PUBLIC HEARING MEMORANDUM

SUBJECT: **Petition #195-23**, for SPECIAL PERMIT/SITE PLAN APPROVAL to raze the existing dwelling and construct four residential units in two buildings with dimensional waivers at 20 Clinton Street, Ward 1, Newton, on land known as Section 14 Block 22 Lot 12, containing approximately 10,404 sq. ft. of land

Re: Special Permit – 20 Clinton Street

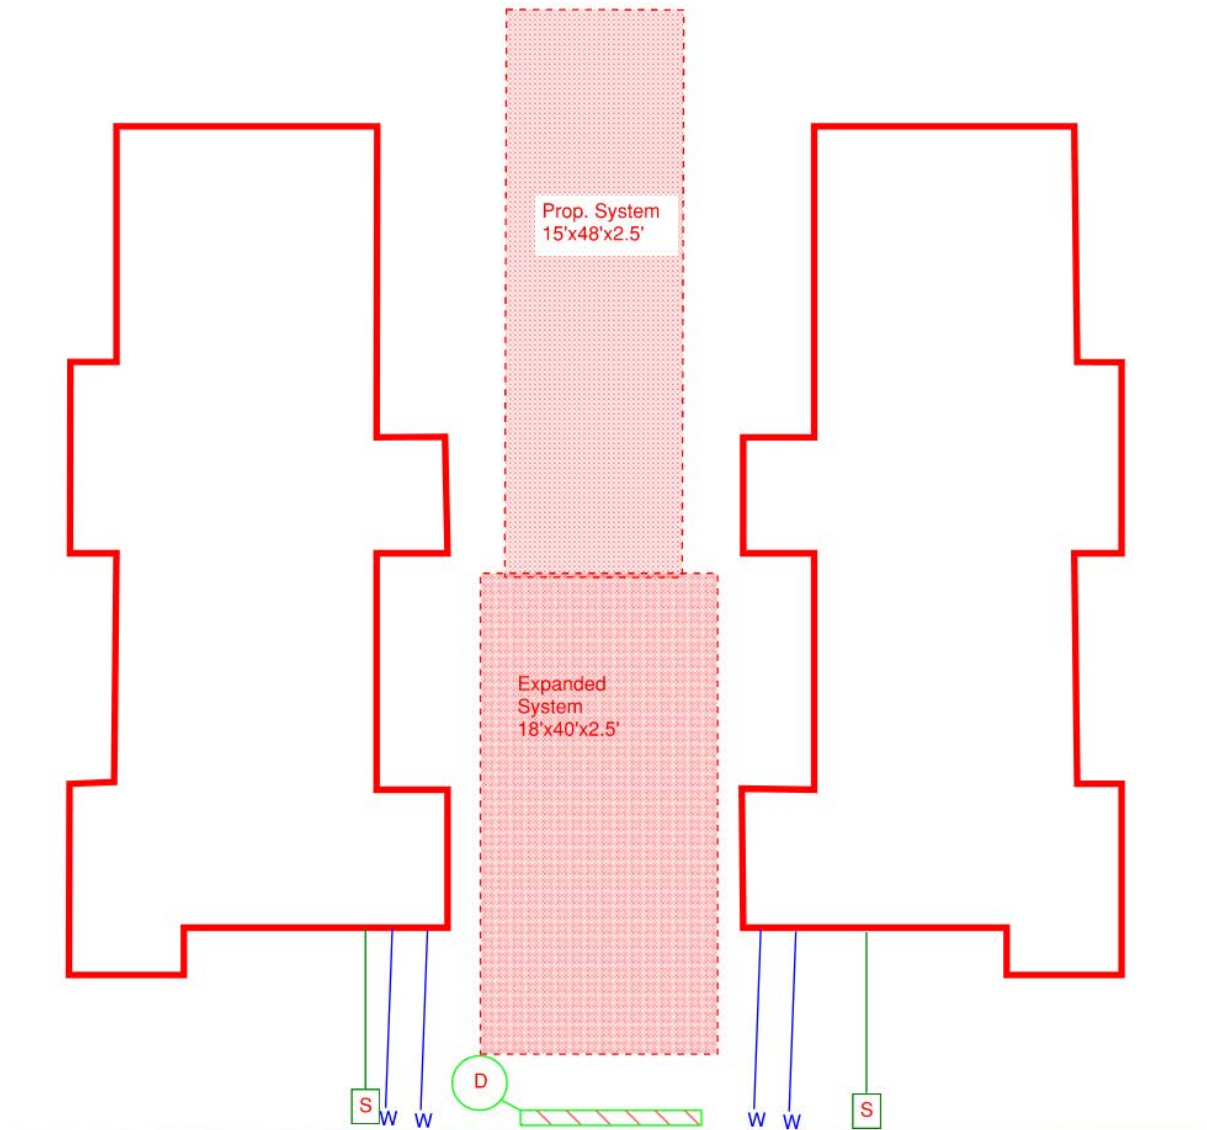
The engineer of record has designed a stormwater collection system in accordance with the City's Stormwater policy & regulations; however, the drainage report has a contradiction on pages 2 & 3 in which statements are made regarding the 2" storm, on page 2 it states:

The infiltration system has been sized to fully storage the runoff from a 2" storm event across all impervious areas, these calculations can be seen on the next page.

However, on page 3 the following statement is:

NOTE: Due to space limitations and the elevation observed for the ESHGWT, in this case we were not able to contain 2" Storm Event, but we have been able to contain 1" Storm Event. Making a system twice as large, with a depth of 2.5', is not possible on this lot, however all other conditions have been met.

If the various utilities are redesigned a system that is double in size can accommodate the required 2" storm. For example, the sanitary sewer connections could be transferred in front of

the two buildings, and a second 40'x 18'x 2.5' system be installed to the north of the proposed system as shown in the following schematic.
